October 26, 2007

Re: Comments on DEIR/EIS Bay Area – Central Valley High Speed Train Program

Shinn Street Station

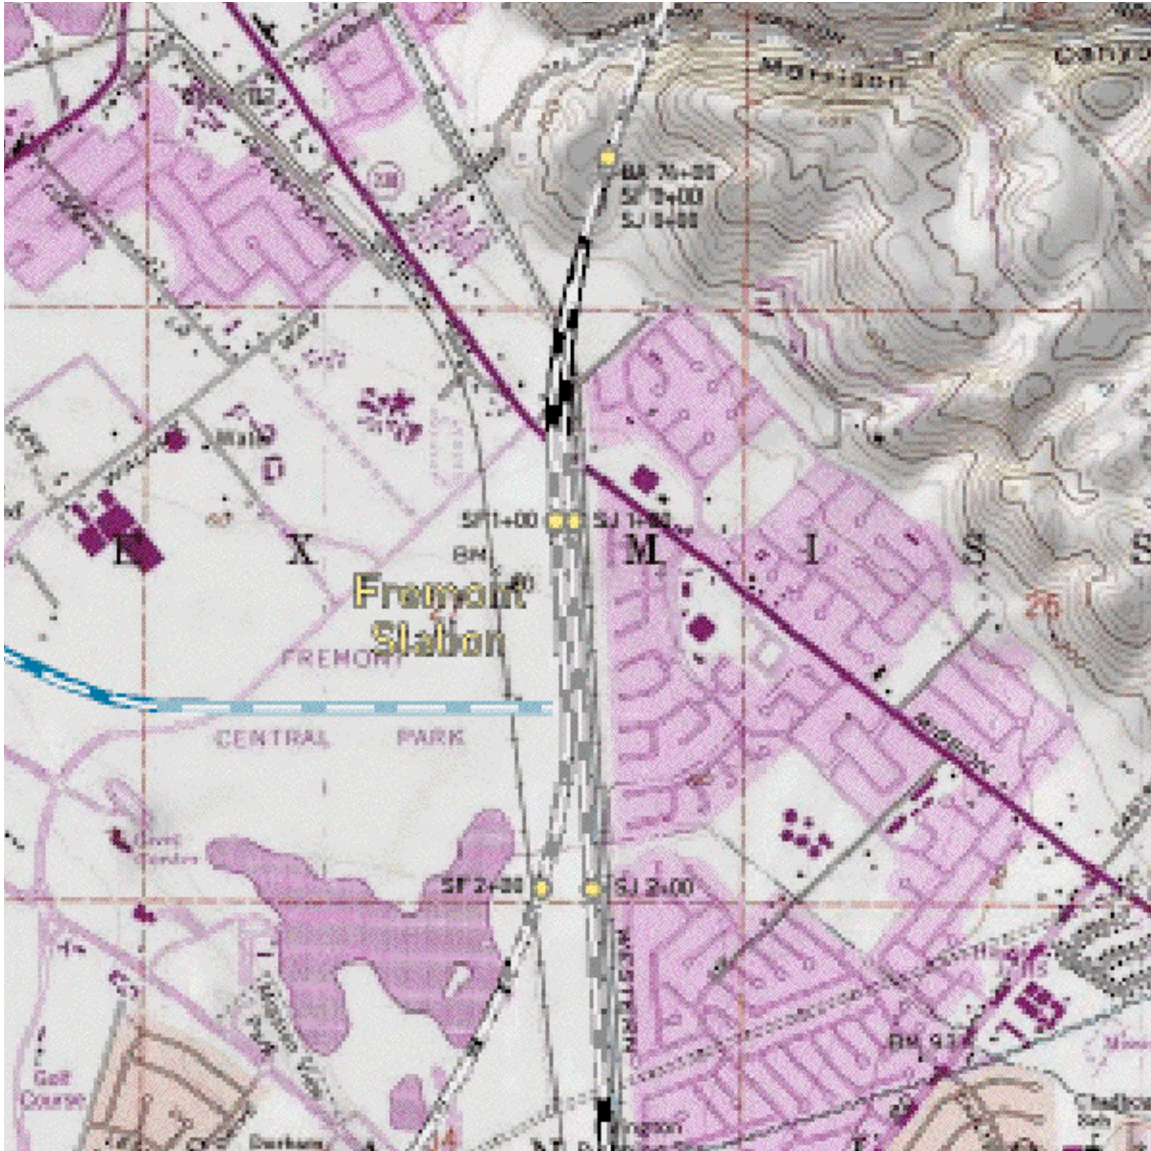
The Shinn Station location is accessed by a single narrow residential street that crosses the Union Pacific mainline, which carries both Amtrak Capitols and ACE trains, at grade. The station site has no transit service and is constrained by rail and industrial development and Alameda Creek and established residential neighborhoods. The existing rail right-of-way is not wide enough to accommodate the 180' station section shown on the Shinn Street Fact Sheet. There is no indication that a connection to BART, less than 1/4 mile west of the station site, is contemplated.

Why is this important intermodal connection overlooked? Wouldn't a connection to BART increase ridership and meet the goal of forging intermodal links? What potential for meaningful joint development is possible on this constrained site? Is the site even capable of accommodating a station?

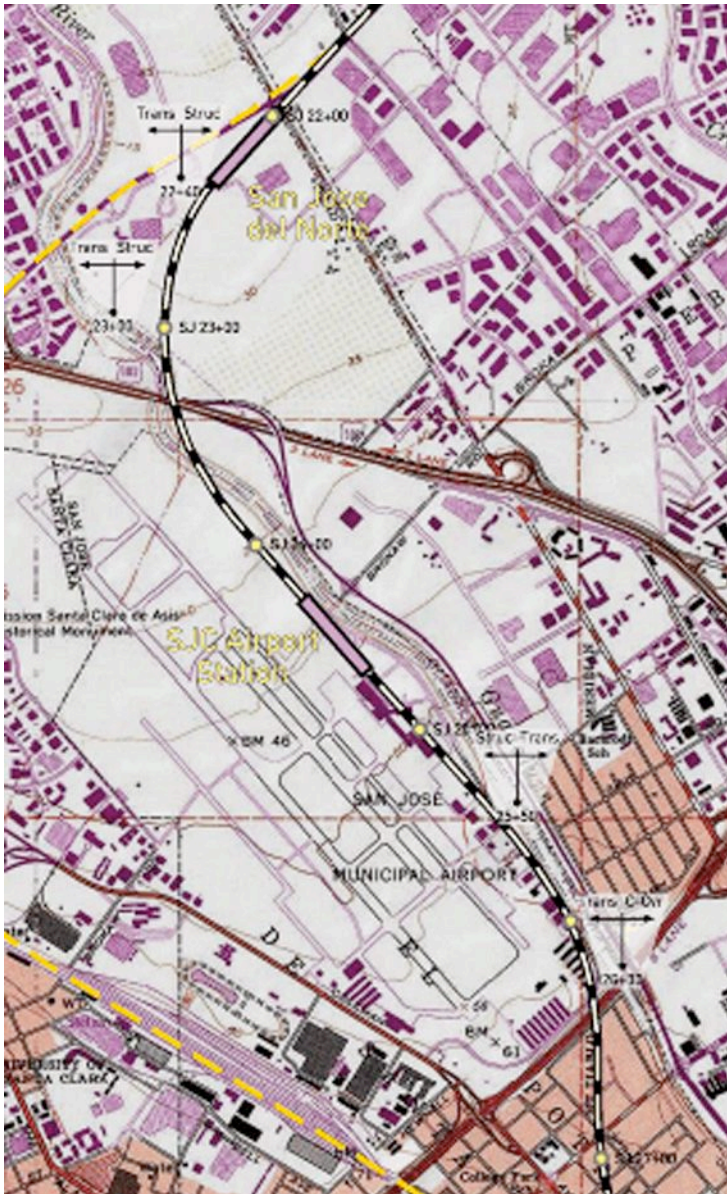
What is the benefit of this option? It traverses more open and agricultural land than the other Pacheco alignment, traverses a more developed area where it requires a junction with the N-S Central Valley line (requiring more homes to be taken for construction) and adds distance and travel time to all trips between stations Fresno and south and the Bay Area.

Placing the Merced station on the Southern California-Bay Area mainline seems a very weak justification for this alignment option. Table 3.2-7, Forecasted Daily Boardings, from the March 23, 2001 Alignment/Station Screening Evaluation Methodology report,

shows Merced with only 514 boardings, third lowest, just above Los Banos and Tulare/Hanford. Most stations have in the thousands, if not tens of thousands. Updated boarding information is unlikely to change relative differences in station boardings.

The GEA seems to lack any significant benefit over the Henry Miller Pacheco Alignment, so it should be dropped from further study.

I-880 UP/BART Alignment

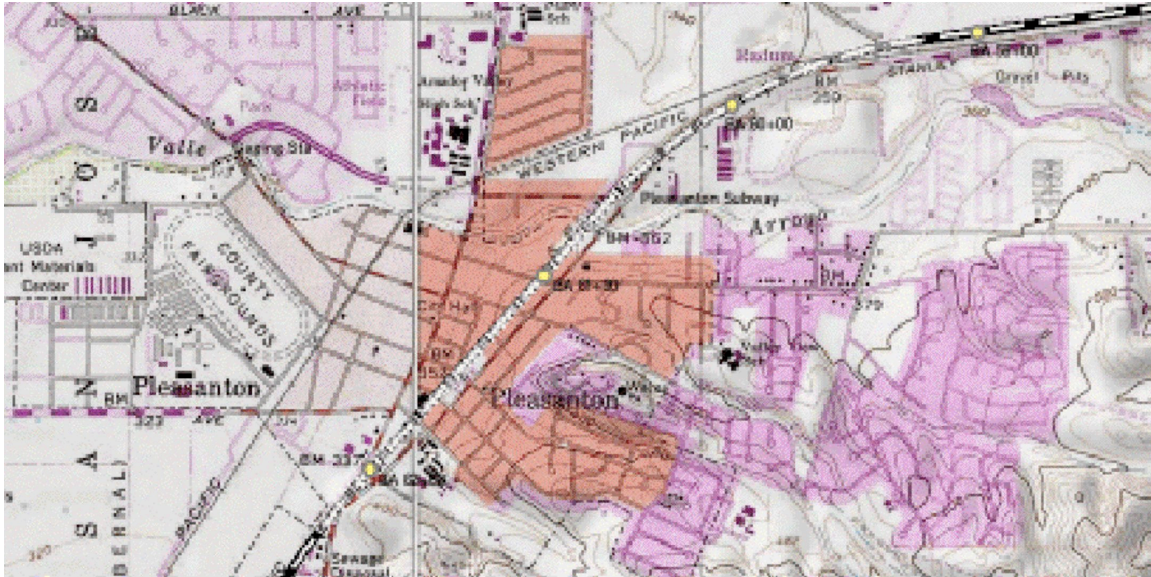
The single option of an elevated alignment for the HSR above the median of I-880 between Fremont and San Jose overlooks the opportunity to utilize the UP/future BART right of way. The Trimble alignment provides an exit from the UP right of way prior to its congested and developed entry into downtown San Jose. While the ability to utilize the UP/BART right of way partially to San Jose, transitioning to I-880 offers little benefit, the UP/BART to Trimble alignment appears superior to the I-880/Trimble alignment.

The joint rail right of way between Stevenson Boulevard in Fremont and Abel Street in Milpitas has sufficient width to accommodate BART, HSR and Union Pacific facilities. South of Abel Street, the proposed BART alignment follows the UP alignment to the east, while HSR would follow the historic SP right of way until transitioning to an aerial structure in the median of Montague Expressway.

Utilizing the BART/UP right of way would allow the HSR to take advantage of the grade separations there, existing and planned, rather than building a complex elevated structure in the median of the I-880 freeway.

I-680/580 Alignment

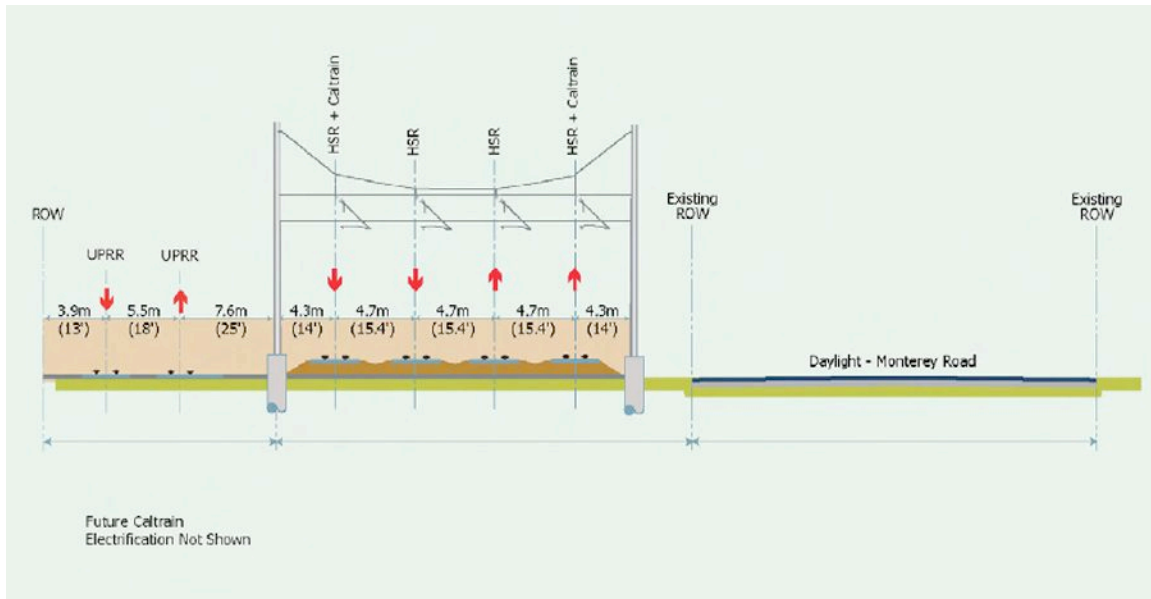
This alignment should be dropped, due to the sharp curvature entering and leaving the I-680 median, the difficulty of building above the median of freeways and BART, and the visual and sonic impacts of an elevated railway.
